<b>Technical Service Bulletin:</b> TSB190014	<b>Released Date:</b> 28-Jan-2019
<b>Damaged Flywheel Housing: Nova Bus™ Chassis</b>

## Damaged Flywheel Housing: Nova Bus™ Chassis

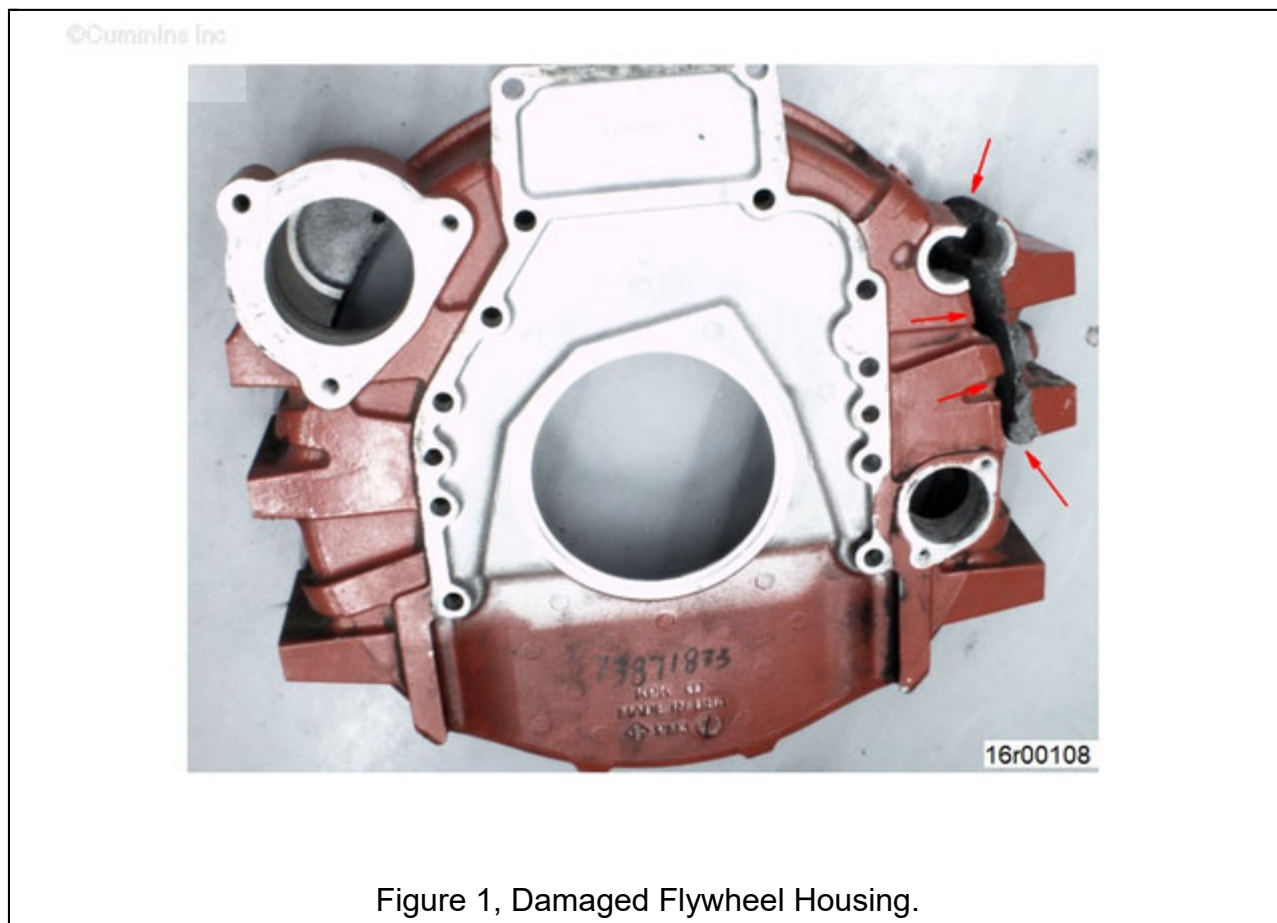
- Visible crack and/or damage of the flywheel housing

- Overloading of the flywheel housing.

Visible crack and/or damage of the flywheel housing at or near the flywheel housing mounting pad location. See Figure 1 below.

Replace existing flywheel housing with new Part Number 5477583.
